# Access Compliance Report

## Public Rights-of-Way

### (Curb Ramps)

Intersection ID: 4258	Main Street: RADBOURNE_BV	Cross Street: WHISTLEY_GREEN_DR	Location: NE
ADA ID: 587FCC0D6DC0	Ramp Type: Perp	Initial Pass/Fail: Fail	Overall Compliance: No
Severity Score: 25			
Codes/Mitigation Info/Possible Solution		Field Measurements/Component Compliance

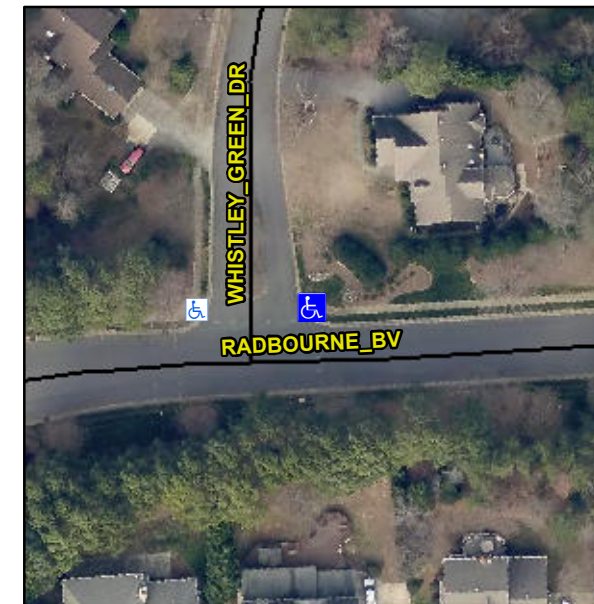
**Not Found, R304.2.2, R304.5.3**

Compliance	Description	Data	Compliance	Description	Data
N/A	Ramp Length (in)	47.0	No	Ramp Slope (%)	10.8
Yes	Ramp Width (in)	48.0	No	Ramp XSlope (%)	6.0
N/A	Flare Type LT	N/A	N/A	Flare Type RT	N/A
N/A	Flare Slope LT (%)	N/A	N/A	Flare Slope RT (%)	N/A
N/A	Flare Traversable LT?	N/A	N/A	Flare Traversable RT?	N/A
N/A	Landing Length (in)	N/A	N/A	DWS Provided?	N/A
N/A	Landing Width (in)	N/A	N/A	DWS Contrast?	N/A
N/A	Landing Slope (%)	N/A	N/A	DWS Length (in)	N/A
N/A	Landing X Slope (%)	N/A	N/A	DWS Full Width?	N/A
N/A	Landing Curb? (Y/N)	N/A	N/A	DWS Offset (in)	N/A
N/A	Shared Landing?	N/A			
N/A	Gutter Ponding?	N/A	N/A	Gutter Slope (%)	N/A
N/A	Gutter Lip Ht (in)	N/A	N/A	Gutter X Slope (%)	N/A
N/A	Painted X Walk1?	No	N/A	Painted X Walk2?	N/A
	X Walk 1 Direction	To W		X Walk 2 Direction	N/A
N/A	X Walk 1 Width (in)	N/A	N/A	X Walk 2 Width (in)	N/A
	X Walk 1 Slope (%)	3.9		X Walk 2 Slope (%)	N/A
	X Walk 1 X Slope (%)	6.0		X Walk 2 X Slope (%)	N/A

**Remove & Replace Entire Ramp.**
